- 1. Timberline Rush Patch Replat; KPB File 2025-162
Mullikin Surveys / Rush, Patch
Location: East End Road & Cannonball Circle
Fritz Creek Area**

TIMBERLINE RUSH-PATCH REPLAT

**ITEM #1 - PRELIMINARY PLAT
TIMBERLINE RUSH – PATCH REPLAT**

KPB File No.	2025-162
Plat Committee Meeting:	February 9, 2026
Applicant / Owner:	David Lawrence Rush and Diane Patch of Homer, AK
Surveyor:	Christopher Mullikin, Mullikin Surveys LLC
General Location:	East End Road and Cannonball Circle, Fritz Creek Area

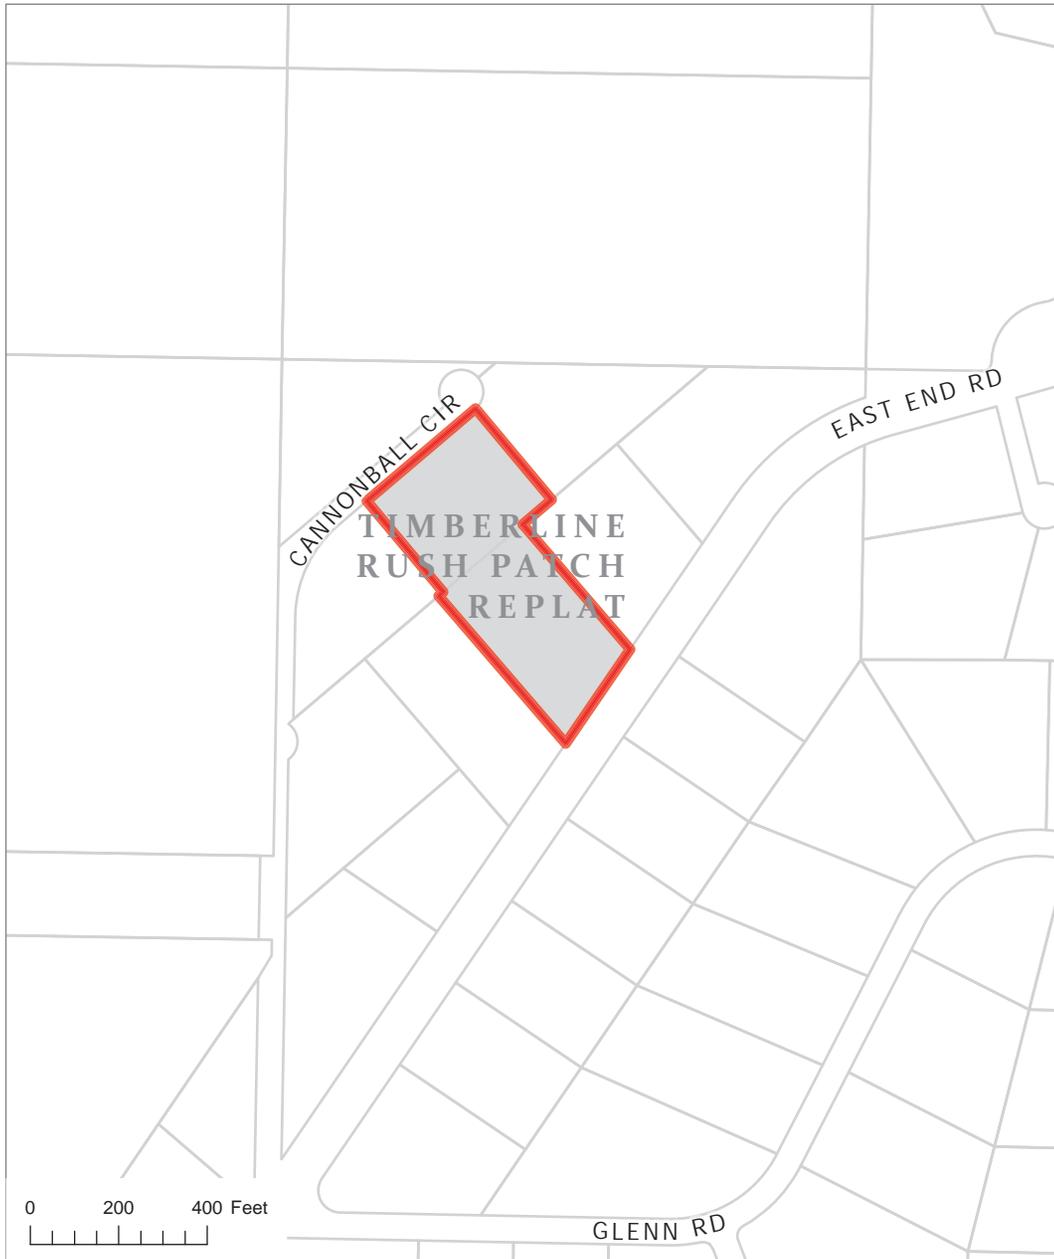
- Revise KPB File No to 2025-162
- Modify plat note #7: The borough will not enforce private covenants, easements, or deed restrictions per KPB 20.60.170(B)

- Lot 3B-1 must take access to Cannonball Circle.
- Lots on East End Road shall have common driveways.

- Label section 7
 - Add a label for Cannonball Circle
- E. All parcels of land including those intended for private ownership and those to be dedicated for public use or reserved in the deeds for the use of all property owners in the proposed subdivision, together with the purposes, conditions, or limitations of reservations that could affect the subdivision;
Staff recommendation:

- Note the covenants, conditions, and restrictions recorded within Book 100, Page 641, HRD, and the amendments recorded within Book 105, Page 948, Book 111, Page 527, and Book 140, Page 500, HRD.

- Modify parcel labels:
 - Lots 2-A and 4-A, Block 1 (HM 79-24)
 - Lots 3 and 4, Block 3 (HM 78-17)
 - Southeastern parcel: Lot 1-A, Block 3, HM 2020-16
- J. Block and lot numbering per KPB 20.60.140, approximate dimensions and total numbers of proposed lots;
Staff recommendation:

- Provide a label for Block 1 to proposed lots
- N. Apparent encroachments, with a statement indicating how the encroachments will be resolved prior to final plat approval;
Staff recommendation:
Garage encroaching property line and utility easement. Reconfiguration of the lots and finalizing the UEV will resolve encroachment

Staff recommendation: Provide a label for Block 1

- Lot 3B-1 must take access to Cannonball Circle.

ENCROACHMENT DIAGRAM

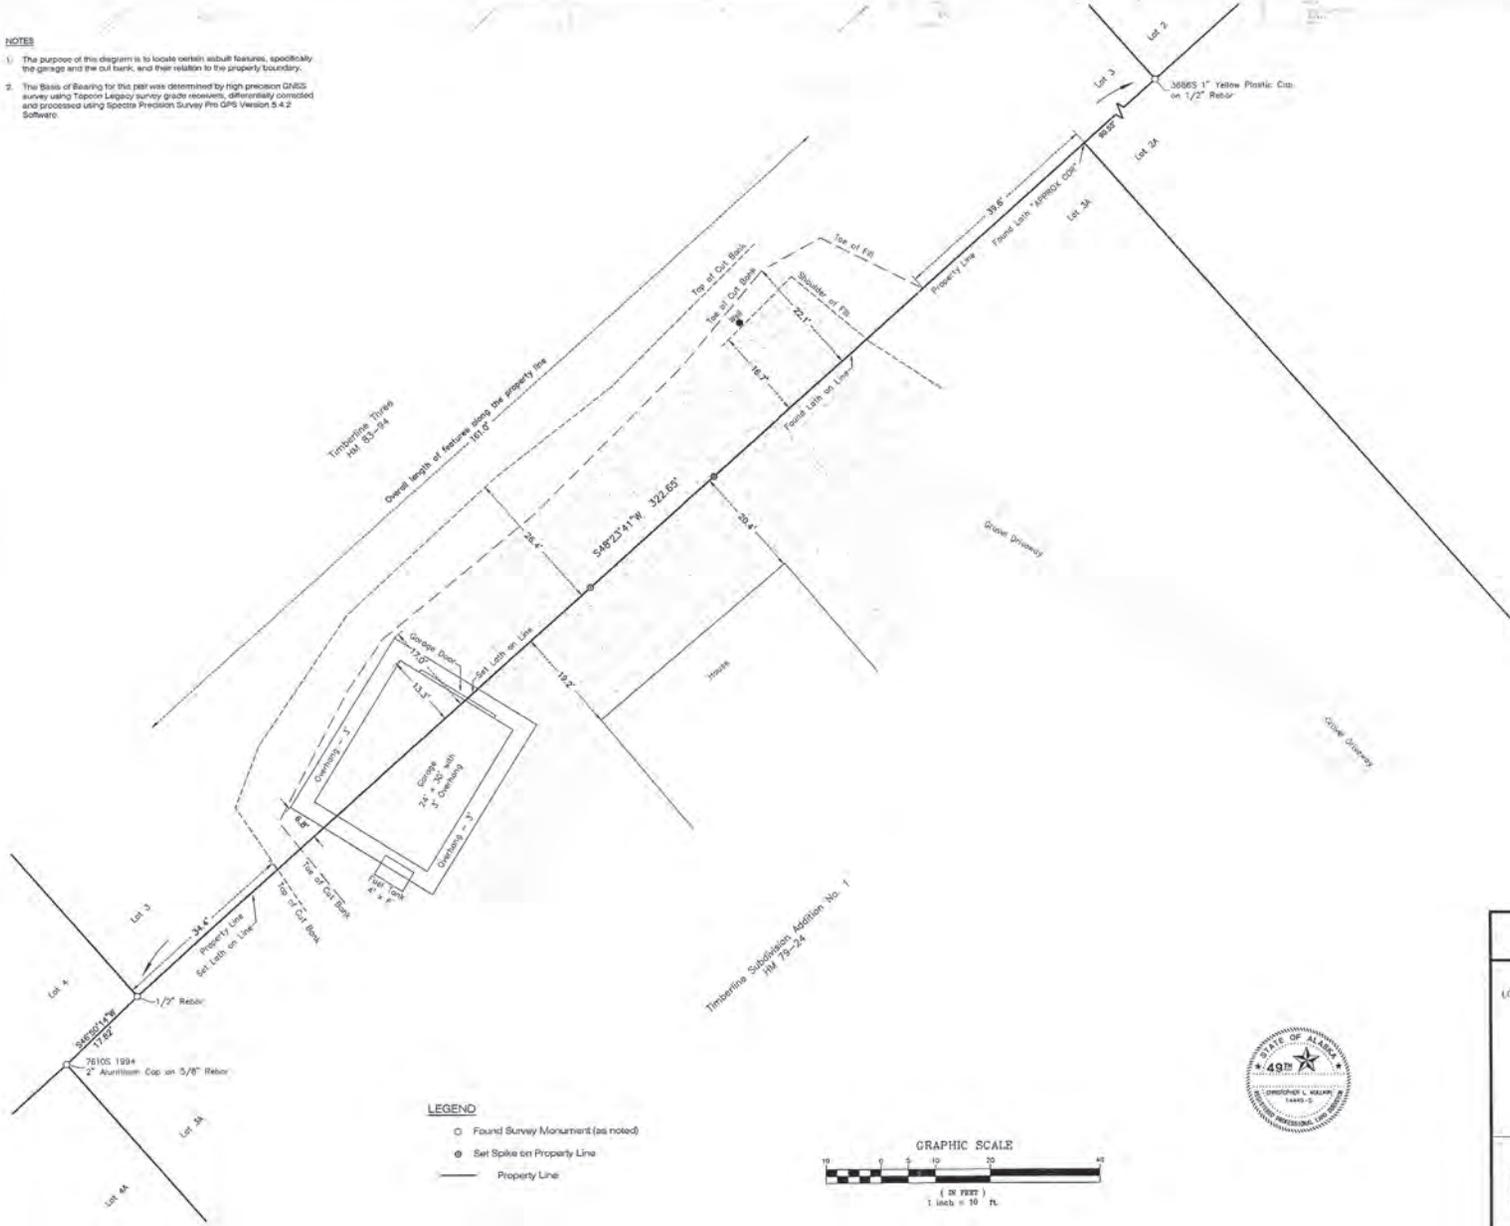
No improvements are shown on the preliminary plat; however, an encroachment diagram was submitted for the former common lot line. The diagram identifies a 24-foot by 30-foot garage situated on the lot line, encroaching into the 10-foot utility easement and crossing the property line by approximately 17 feet. The proposed lot reconfiguration will resolve this encroachment.
